Access Compliance Report Public Rights-of-Way (Curb Ramps)

Main Street: TISBURY_WAY		Cross Street: FLINTRIDGE_AVE		Location:	W
ADA ID: RPRK211104134254	Ramp Type: Type 4 - Parallel	Initial Pass/Fail: Fail	Overall Compliance: No	Severity Score:	16
Codes/Mitigation Info/Possible Solution			Field Measurements/Component Compliance

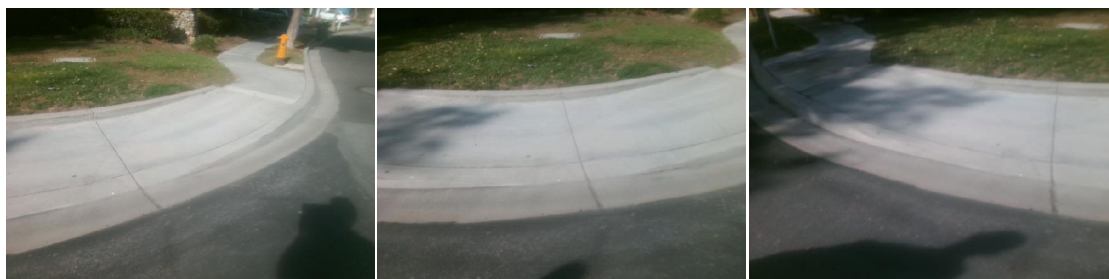
R204.3, R304.3.2, R304.5.3, STD 1115

Remove & Replace Curb Ramp With Two New Directional Ramps or Equivalent.
